**Re: Maplegate South Solar Array
Site Plan Peer Review**

BETA Group, Inc. is pleased to continue our engineering peer review services for the proposed project entitled **Maplegate Solar Project South** in Franklin, Massachusetts. This letter is provided to outline findings, comments, and recommendations.

RE: Maplegate Solar Development Project – South Parcel (Maple Street LLC)

SHEET NUMBER:
C-301

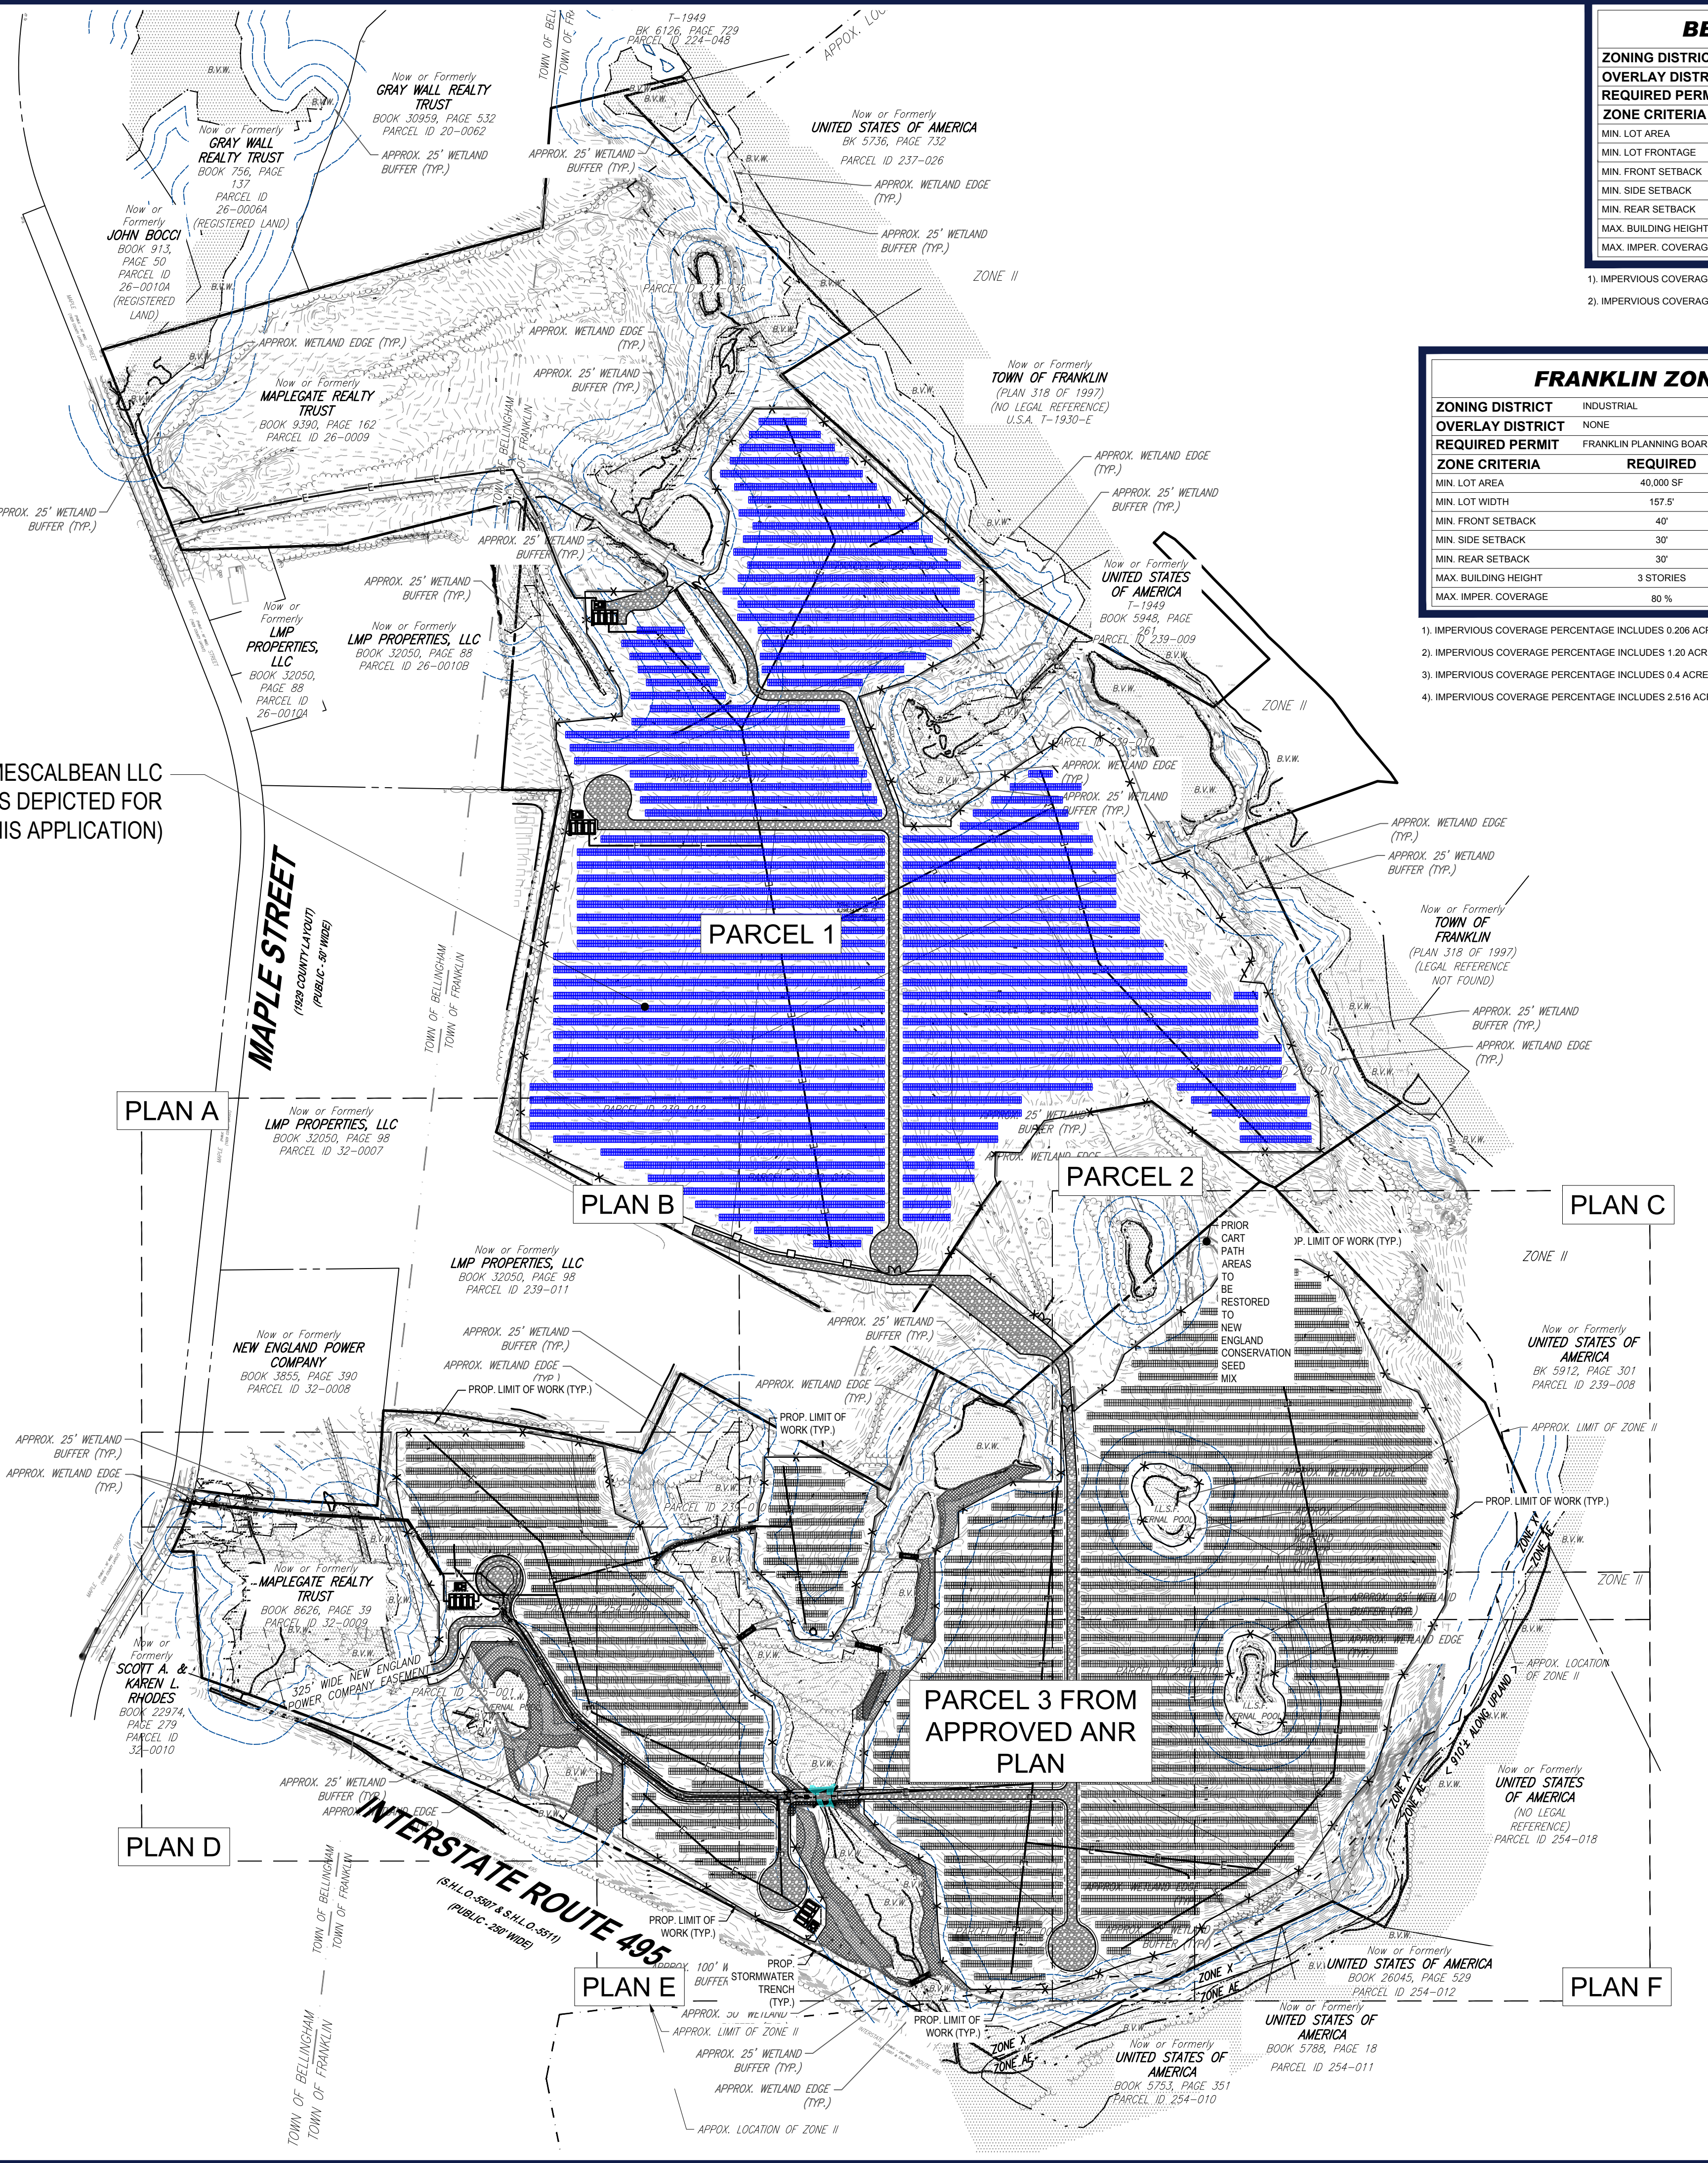
As shown on the schedule on the Zoning table on Sheet C-301 of the set, the Site meets the requirements for lot area, depth, frontage, width, yard widths, building height, and impervious area coverage.

The only way to access the North Project/North Array will be through the 160 Maple Street driveway. That driveway will proceed southerly through the North Project, across Parcel 2, and down into Parcel 3, the South Array. The Site Plans filed with the South Project application in July 2023 accurately portray the access. See [maplegate south - site plans with 7.21.2023 filing.pdf \(franklinma.gov\)](#). The access depicted in the Site Plans is the same as what was shown and filed as part of the North Parcel approval. A screenshot of the July 2023 Plans, sheet C-301 is provided below:
